FINDINGS OF FACT and FINAL ORDER TYPE III APPLICATION

DATE OF MEETING:	August 1, 2025
FILE NO.:	25-037 DR_VAR
PROJECT NAME:	Basketball Court Shelter Variances
APPLICANT/OWNER:	Tiana Rundell/City of Sandy
ADDRESS:	18200 Meadow Drive/Deer Pointe Park
MAP/TAX LOT:	25E18CC 13400 and 25E18CD 01600
SIZE OF PROPERTY:	3.16 acres
ZONING:	Parks and Open Space (POS)
STAFF CONTACT:	Patrick Depa, Senior Planner

(Figure 1)

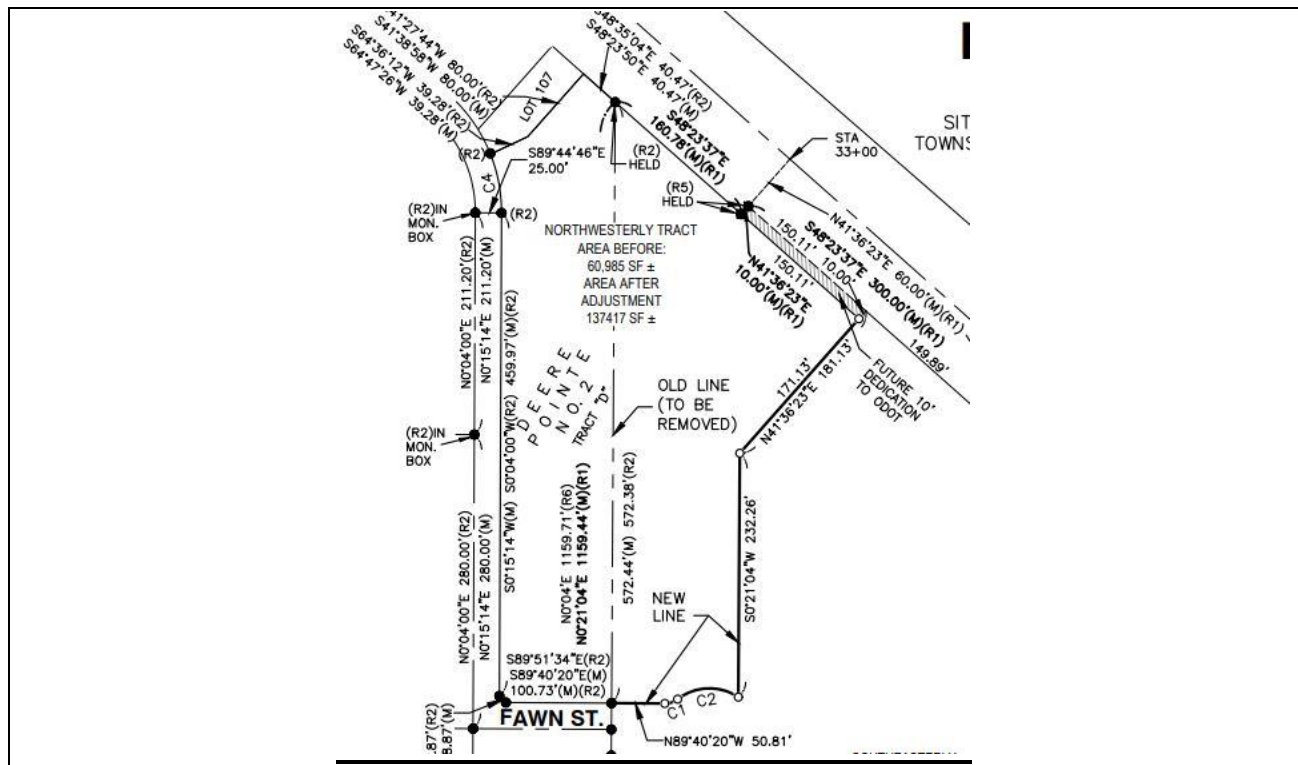
Finding 1. The placement of the basketball court crosses the common property line and several walkways meander between parcels to other park structures and amenities. The applicant submitted a Property Line Adjustment application (File No. 25-002 PLA) along with a draft survey to combine the two parcels. That application was approved with conditions by the Planning Division on February 26, 2025. **The applicant shall record the property line adjustment associated with File No. 25-002 PLA prior to issuance of the certificate of occupancy for the basketball shelter (see Figure 1).**

(Figure 2)

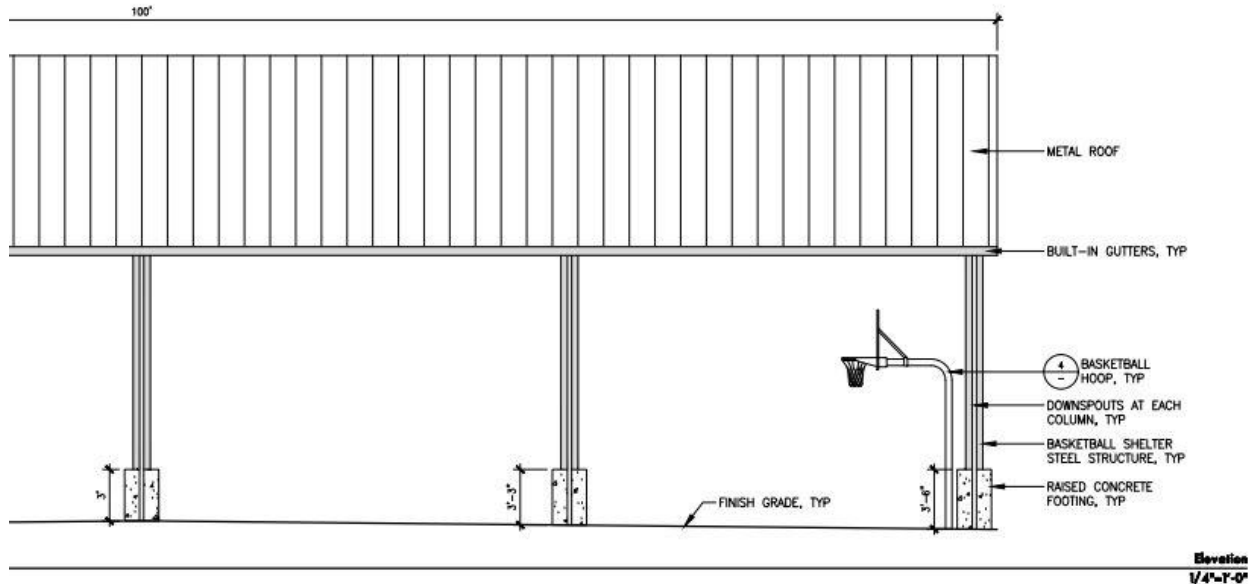
Finding 8. The basketball court shelter has a similar open-air design (no walls) as the proposed picnic shelter already approved for the park. However, where the picnic shelter has steel columns wrapped in stone that meet the above requirement to include strong base materials such as natural stone, split-faced rusticated concrete block, or brick, the basketball court shelter columns are not proposed to include such materials. The columns on the basketball court shelter are proposed to be steel but, will be set in a raised concrete base/footing (see Figure 2). The exposed footings are proposed at 36-inches in height in standard grey concrete, but without a stone wrap. This requires a variance to Section 17.90.120.B.3.b. The applicant applied for a Type III Special

(Figure 3)

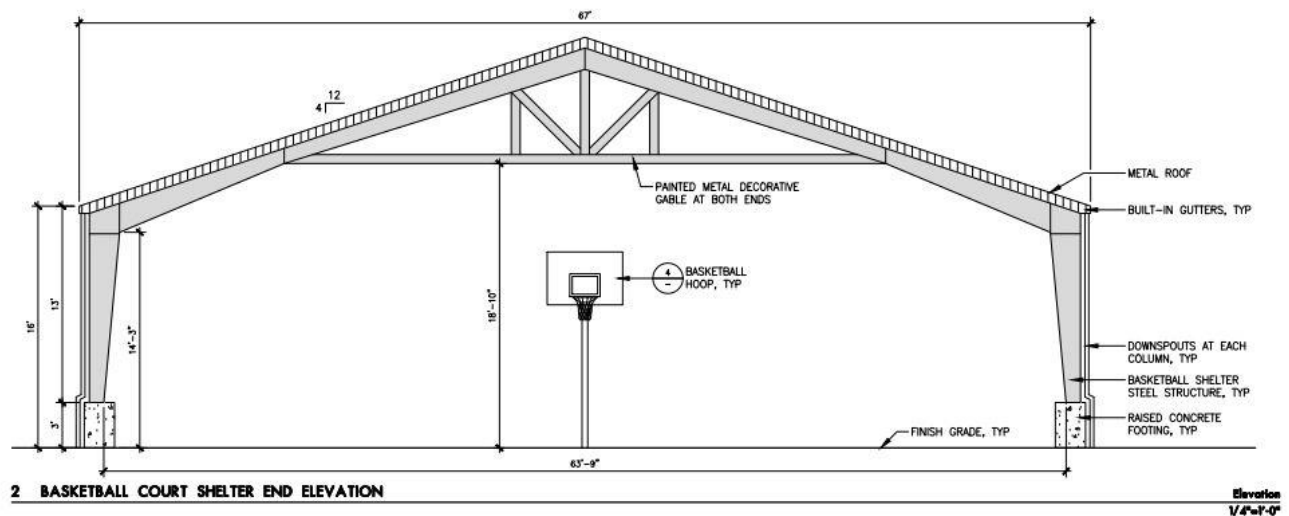
The open gable ends are comprised of painted metal decorative beams with a Howe style truss at both ends of the structure (see Figure 3). Neither gable end faces a street but both ends fall short of satisfying the requirement to include at least three “Sandy Style” design features. The materials used in the gable ends of the shelter can be modified to meet the requirements of this subsection and the number of design elements needed to meet the intent of this section.

At the quasi-judicial public hearing on July 28, 2025, the Planning Division recommended that the applicant apply a dark base coat of paint on the exposed beams and brush on a different lighter color with a grain roller to achieve a wood style finish. The Planning Commission discussed the merits of the staff recommendation but had concerns about how the wood style finish would appear on steel I-beams and were also concerned about graffiti. However, the Planning Commission decided that painting the I-beams one solid color and painting the wood grain on the gable ends would be required. **The applicant shall submit details on the painted-on wood grain for the gable ends. Also, the Planning Commission conditioned the installation of multiple heavy metal brackets at all connection points in the two gables to replicate a Sandy Style design and finish.** This is also emphasized under *Finding 27*.
